MEMORANDUM - Amendment

1. This memorandum refers to the Pre-development Arboricultural Report of 12/01/20 (plus amendments dated 28/05/20) for Plot 8 Rheda Park, Frizington prepared by Treescapes Consultancy Ltd. That report was written in accordance with the current British Standard BS5837:2012 Trees in relation to design, demolition, and construction – Recommendations.

Rheda Park, Plot 8

Plan 2
Tree Constraints Plan showing the approximate proposed site layout and the approximate locations of the trees.

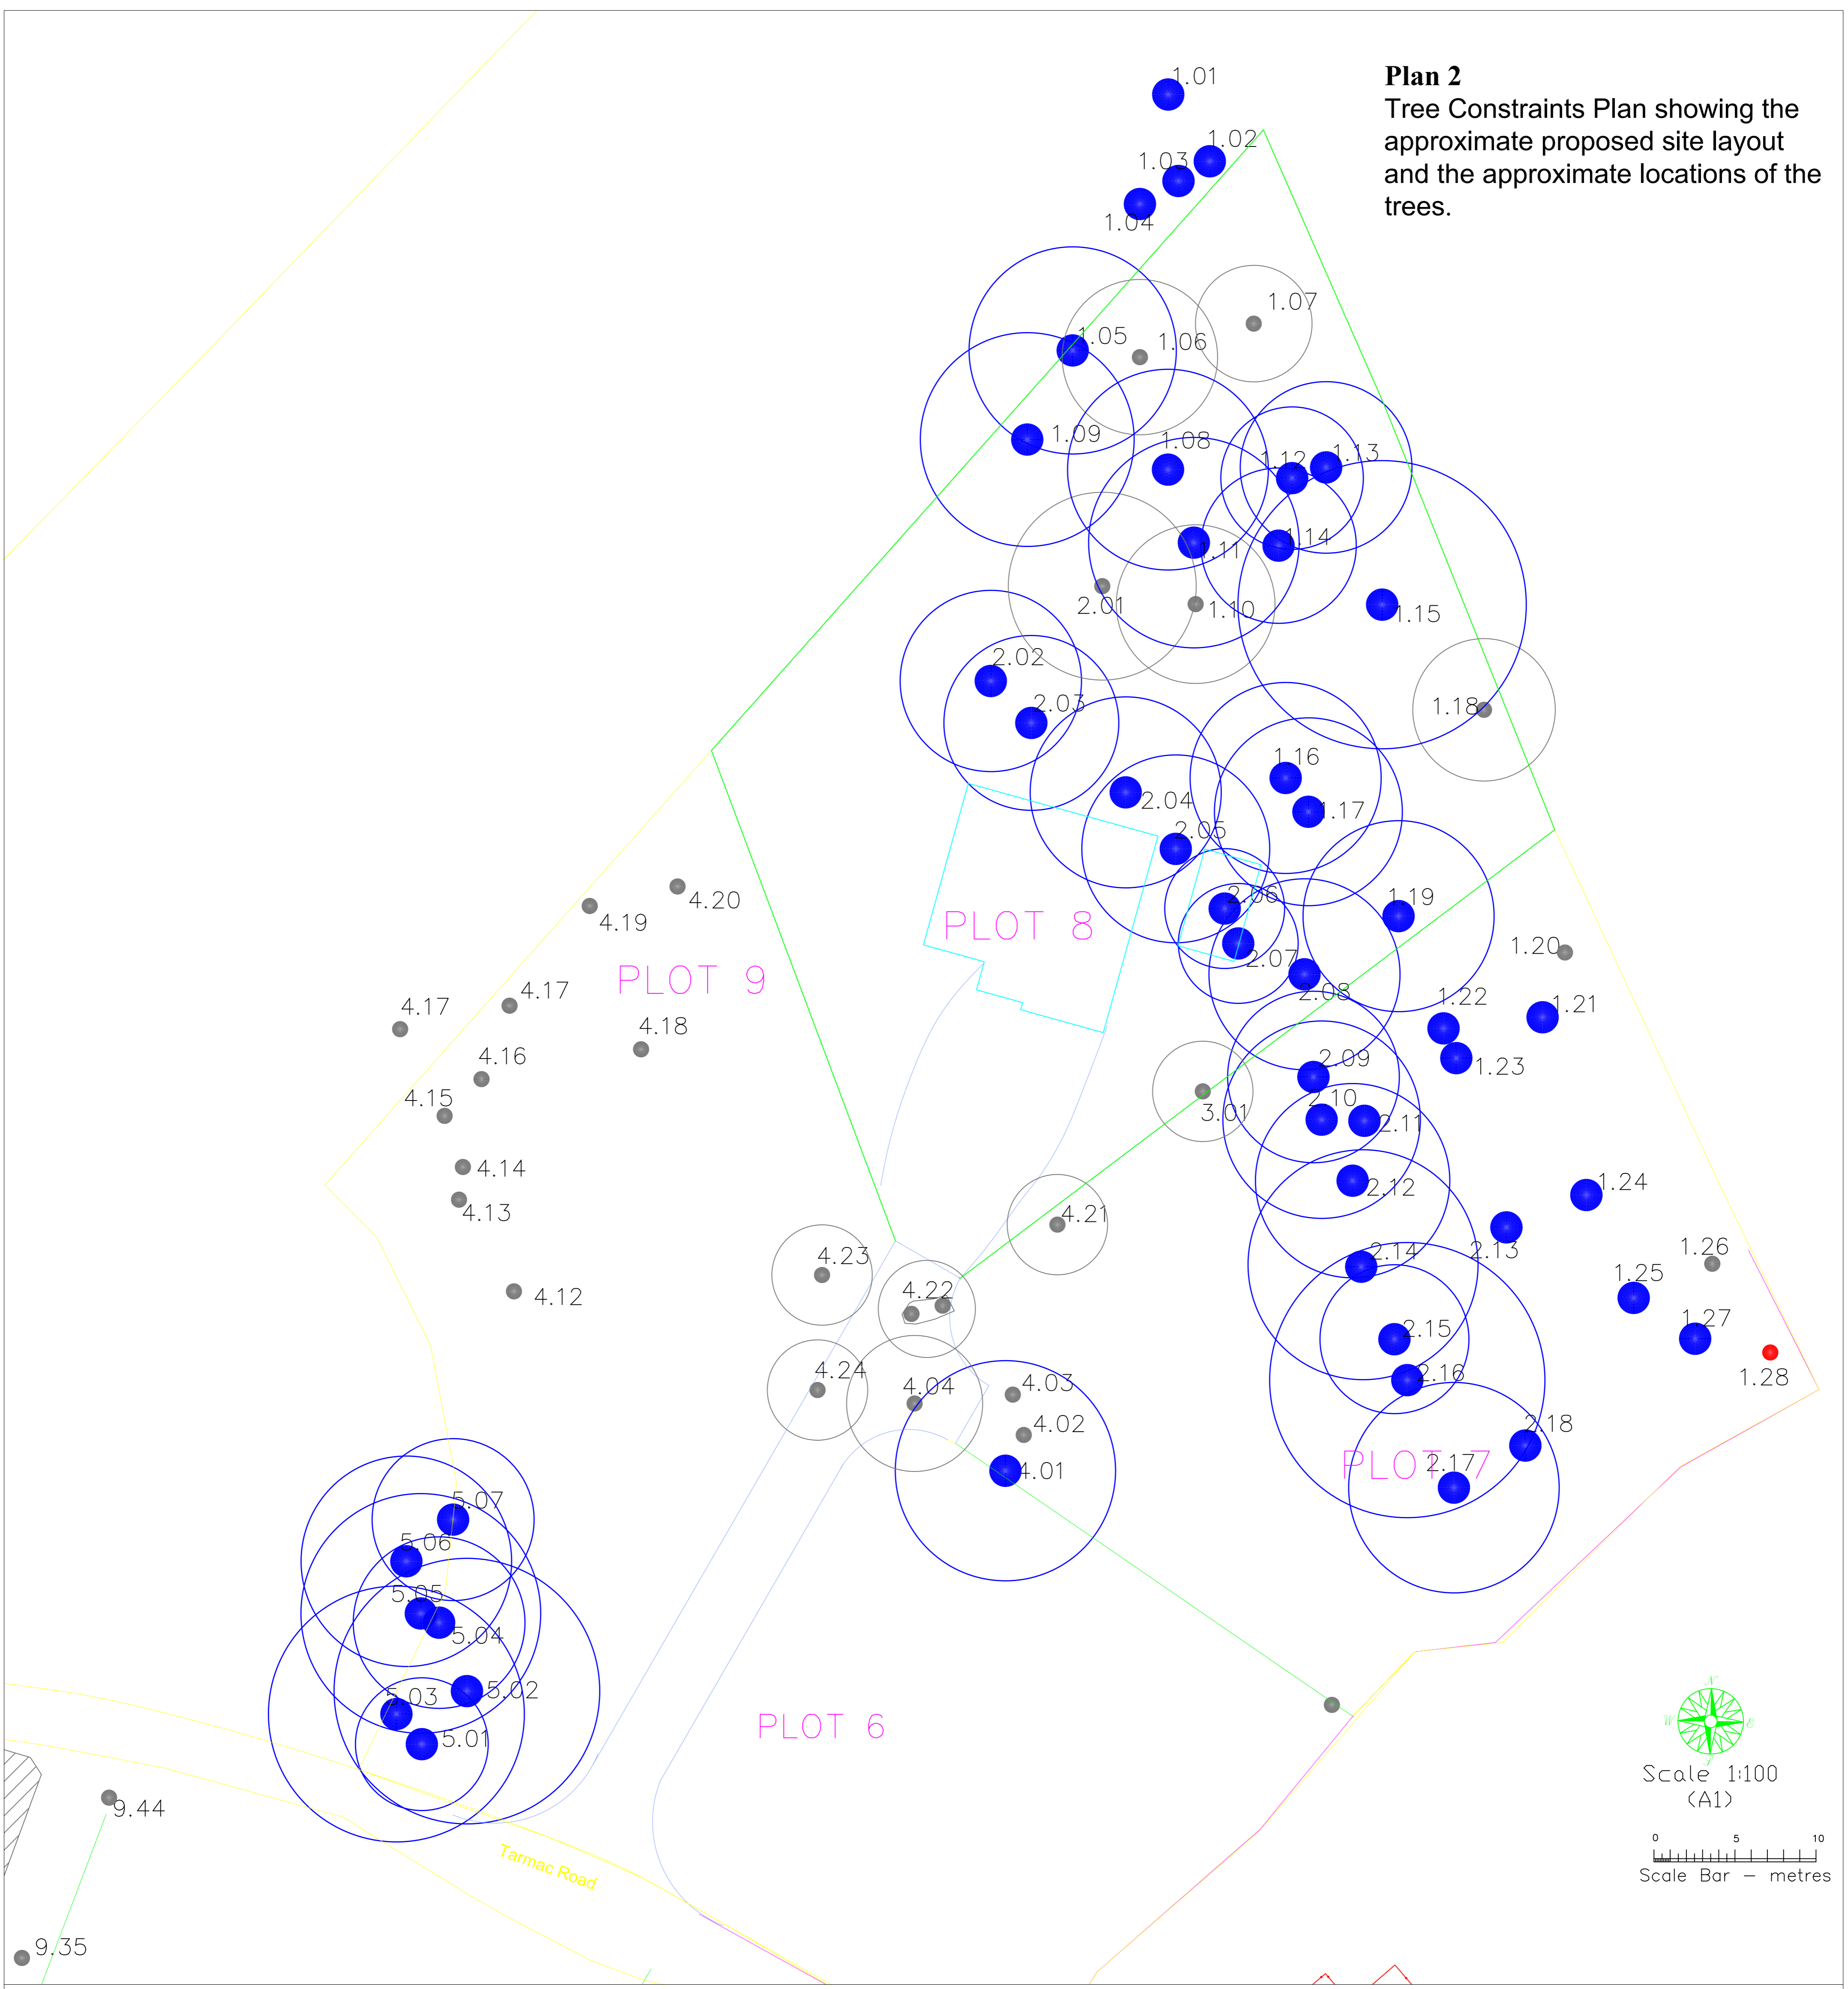
4. On behalf of Mr Lock, I was provided by Craig Wallace of CJW Surveys Ltd on 02/12/22 with a digital drawing of the layout that I understand to be that for which permission has been granted. Accompanying this memorandum is an amended Plan 2 – Tree Constraints Plan based on that drawing.

I consider that there will be three trees, further to those identified in Table 1 of the report, that are also with root protection areas (RPAs) and canopies that encroach into the footprint of proposed structures or within 2m of them. I consider it likely that these three trees will now also to be adversely impacted by the development as granted. They are trees 1.16, 1.17, and 2.08. NB I am advised by Mr Lock that tree 2.08 has already fallen.

Plan 3
Tree Protection Plan showing the approximate proposed site layout and the tree protection measures.

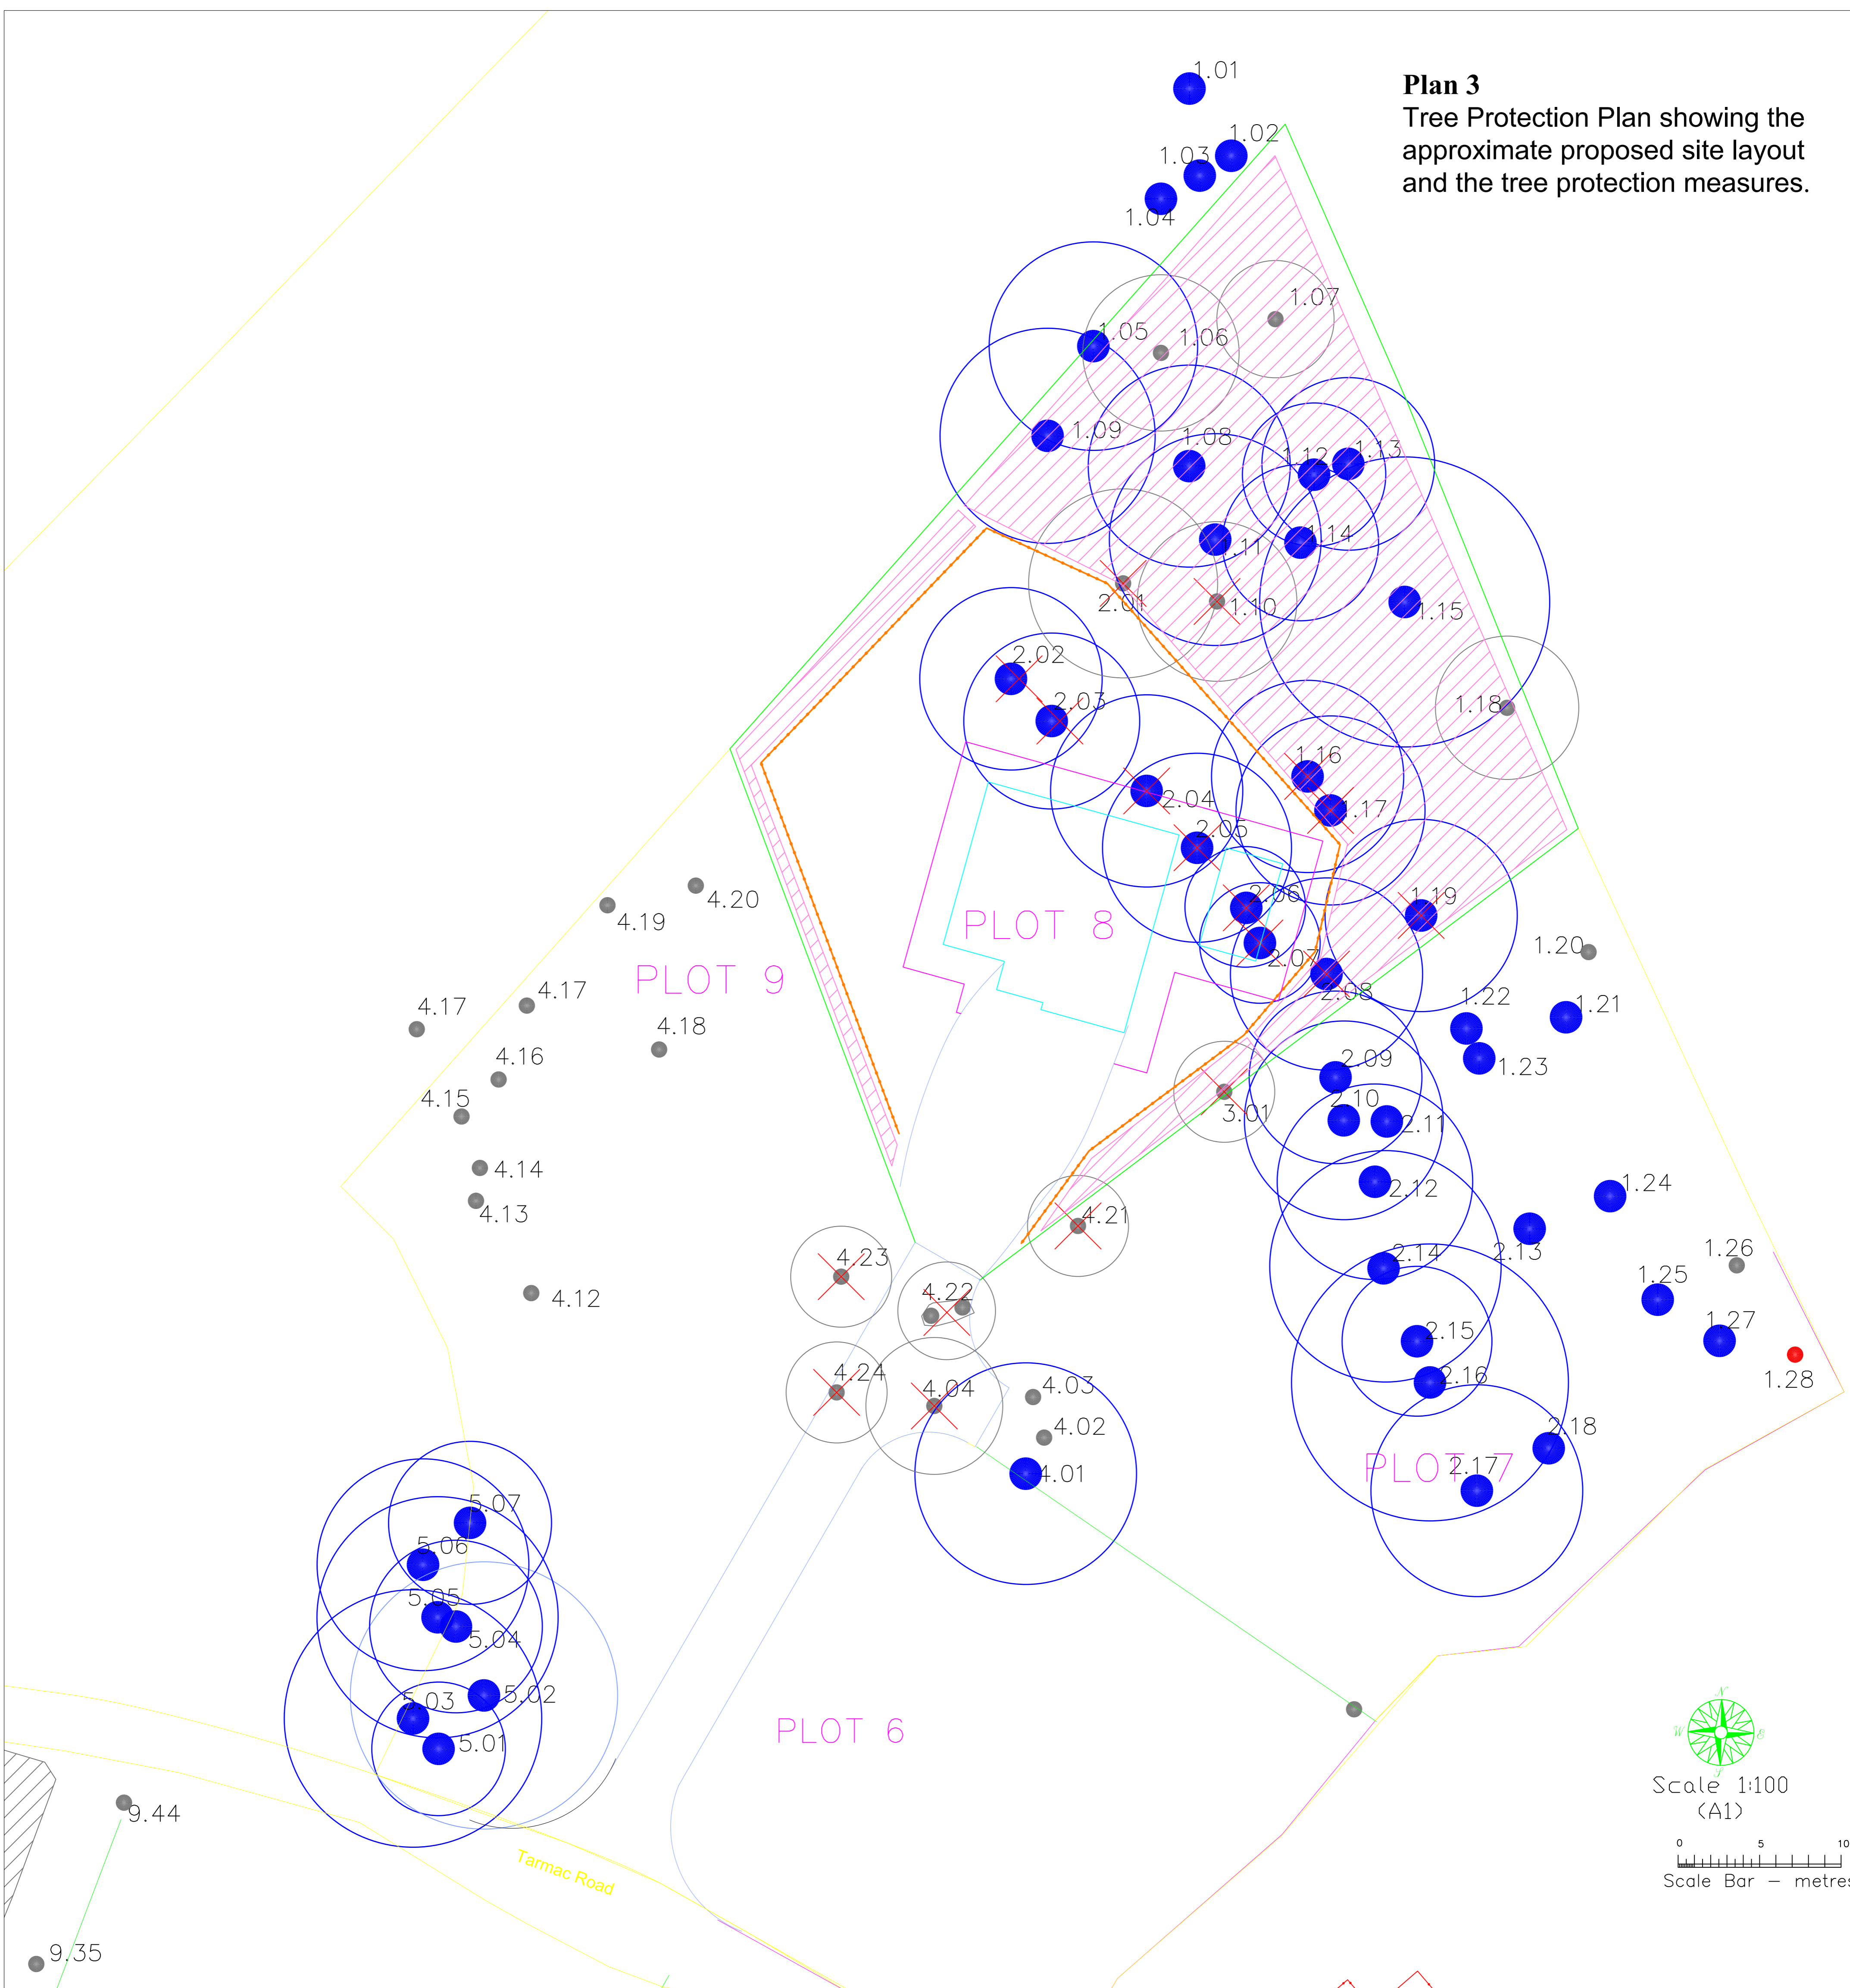
5. In addition to those trees now impacted by development (as above) I recommend that tree 1.19 also be removed before the building works are undertaken. It will be sufficiently close to one of the structures so that an application to remove it in the future may be foreseen. I believe that to do so now as part of the planning consent would be both expedient and wise.

6. In Section 6 of my report, I made recommendations for various tree works to facilitate the proposed development in Plot 8, how they should be implemented and how any retained trees should be protected. In addition to those recommendations, and further to tree 2.08 having fallen, I now recommend that trees 1.16, 1.17, and 1.19 in Plot 8 should also be felled.

7. As page 3 of this memorandum is an amended Plan 3 - Tree Protection Plan showing all the trees I now recommend be felled in Plot 8 (including tree 2.08 for completeness) and my recommendations for protecting those trees to be retained. Appendix 7 of the original report shows suitable tree protection barriers and temporary ground protection measures.
